UNITED STATES PATENT AND TRADEMARK OFFICE

| APPLICATION NO. | FILING DATE | FIRST NAMED INVENTOR | ATTORNEY DOCKET NO. | CONFIRMATION NO. |
|--|-------------|----------------------|---------------------|------------------|
| 10/072,327 | 02/06/2002 | Franck Bellon | EGYP-020 | 3147 |

| Office Action Summary | Application No. 10/072,327 | Applicant(s) BELLON, FRANCK | |

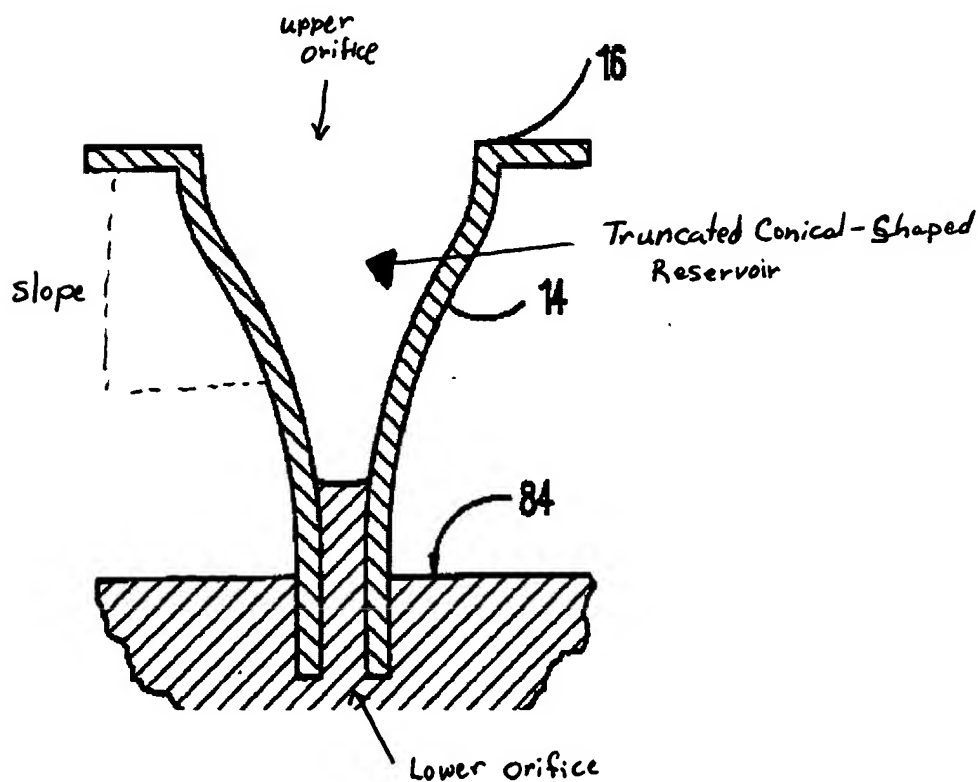
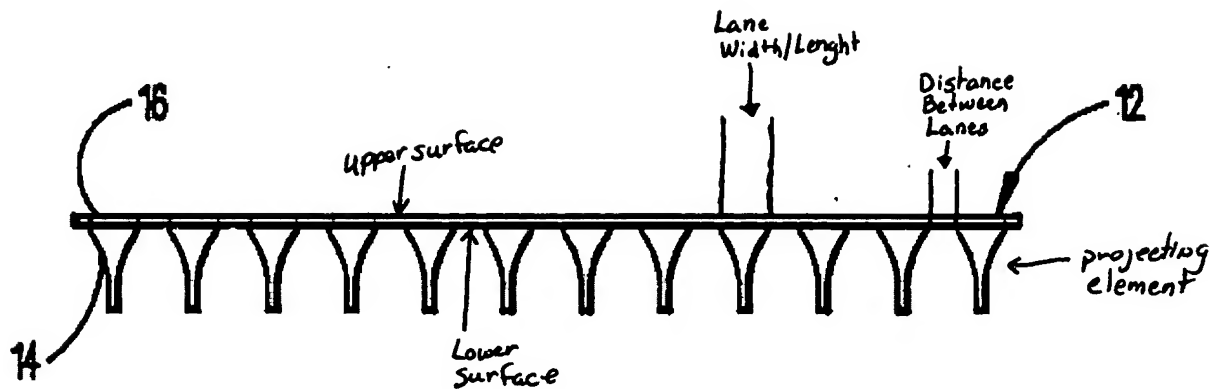
The pipette sheet 12, as illustrated in FIGS. 1 and 2, is an array of 96 pipette cavities 14 depending downwardly from an integral flat sheet 16. A precision die is used to thermoform a 0.015 to 0.020 inch polyvinylchloride (PVC) plastic (rigid material) sheet so that each cavity 14 is identical.

Refer to labeled figures below for examiners interpretation of elements equivalent to as claimed by applicant.
